**ASSESSMENT UNDER DEVELOPMENT CONTROL PLAN SECTION B2 and A1
DA24/0196 - construction of shop-top housing comprising three levels of basement
carparking, ground floor retail premises and 72 units, pool and associated
vegetation removal (NRPP) at Lot 1 DP 807977; No. 3 River Terrace TWEED HEADS;
Lot 2 DP 807977; No. 5 River Terrace TWEED HEADS; Lot 5 DP 9056; No. 7 River
Terrace TWEED HEADS**

Above: Monastery Lane topography to River Terrace.

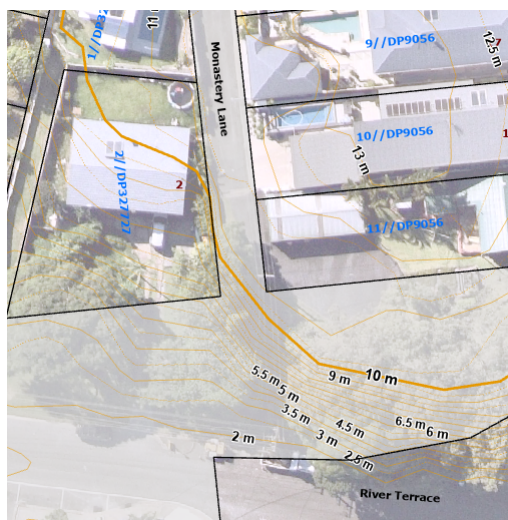
Not applicable. It is noted that Section 8.1.4 includes a map suggesting connection of Monastery Lane to River Terrace. This is not feasible noting the steep drop from the dead end of Monastery Lane to River Terrace/Terranora Terrace.

Above: Site Plan excerpt showing awnings.

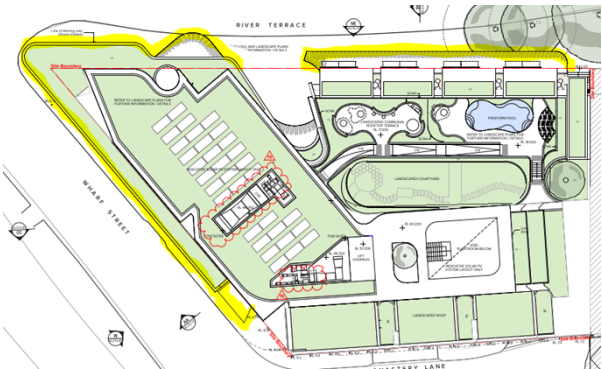
A wrap-around awning is provided from Wharf Street to River Terrace. A break in the awning is provided for the landscaping and entrance area to the internal area of the site. A further awning is provided for the Retail 1 area following the break. The awning includes cascade landscaping (greened areas) with the remainder using the materials below.

Awnings are required to be 600mm from the road. A condition is recommended in this respect. Revised Plans demonstrating 600mm clearance will be conditioned to be submitted prior to issue of a construction certificate.

Above: Materials and finishes of awnings.

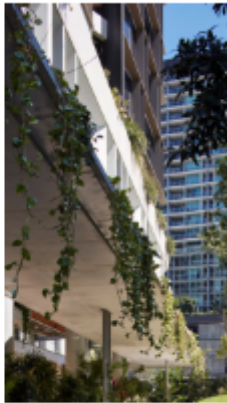
AWN2 Concrete off form awning with stepped profile leading edge, COF1 finish. Integrated GRC planters, colour and finish equal to CPC4.

Above: Basement Floor plans (01 and indicative 02 and 03) showing driveway grades.

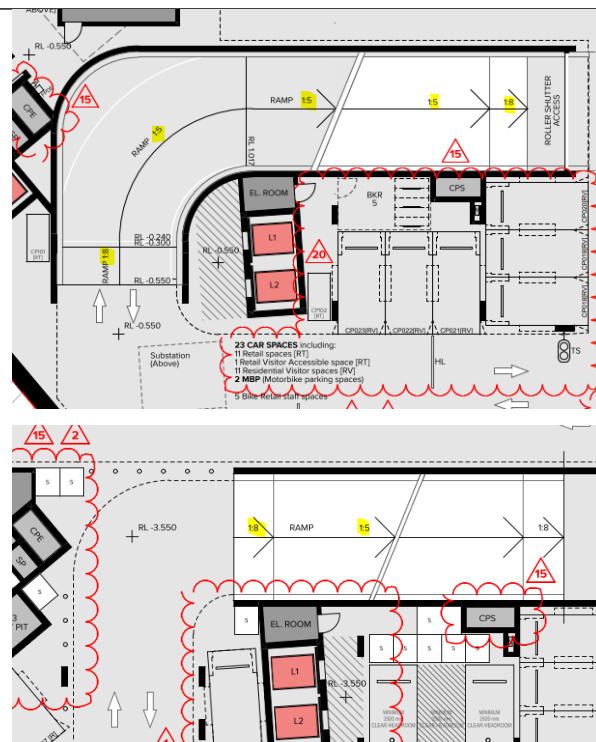
g) Driveway grades, vehicular ramp width/grades and passing bays must be in accordance with the relevant Australian Standard (AS 2890.1).	No concerns were raised with respect to driveway grades (see also below), the ramp or the proposed use of holding bays and traffic lights in the basement for the ramp.

h) Vehicular ramps less than 20m long within developments and parking stations must have a maximum grade of 1 in 5 (20%). Ramp	Complies.

Above: Figure 6 Southern Boat Harbour Special Area Plan excerpt from Section B2 of the DCP.

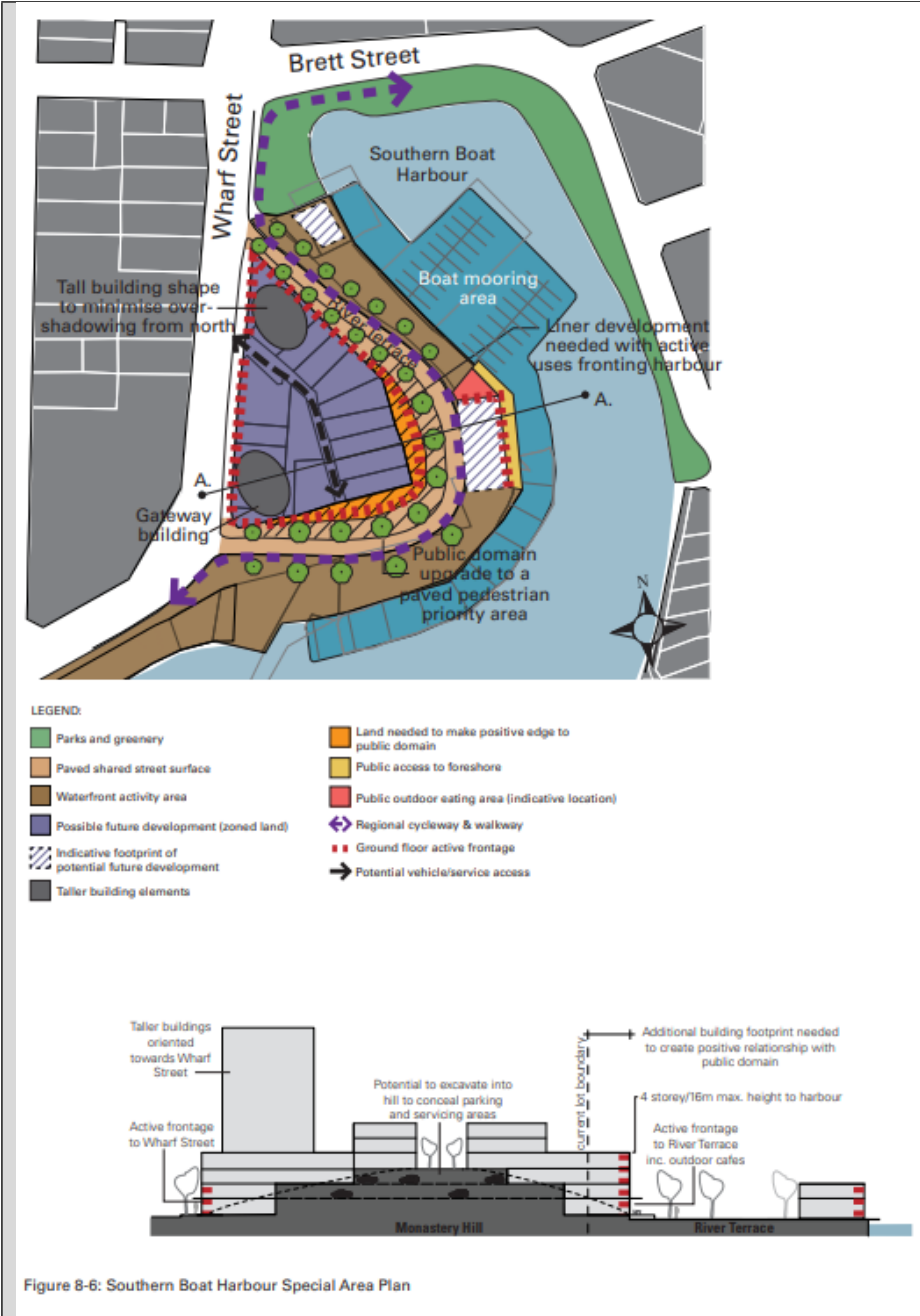
The DCP refers to a land consolidation plan (Figure 8-7), which has not been included in the DCP. The site consolidates three allotments to achieve a more desirable outcome. The FSR control in the LEP encourages sites to be around 2,000 square metres in area. The site is only 151 square metres less than 2,000 square metres in area and an appropriate built form outcome has been achieved.
